PCN-20230619 TE0726-03 to TE0726-04 Hardware Revision Change

Company	Trenz Electronic GmbH
PCN Number	PCN-20230619
Title	TE0726-03 to TE0726-04 Hardware Revision Change
Subject	Hardware Revision Change
Issue Date	2023-10-04

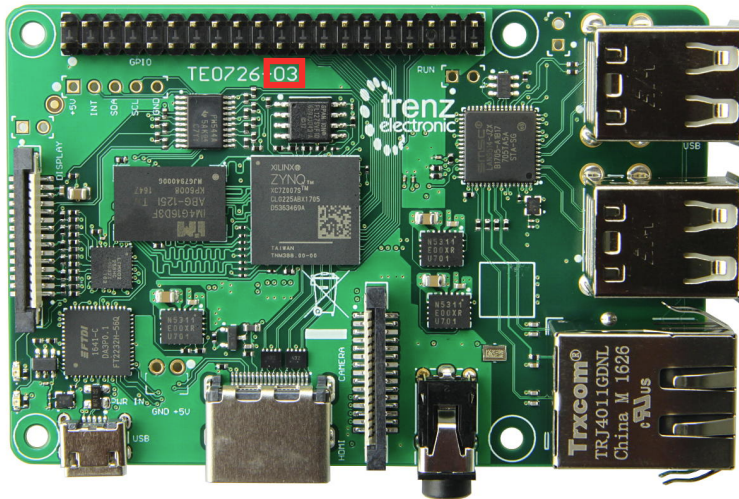
#21 Added legal notices, revision history, block and power diagram. Updated page count and order.
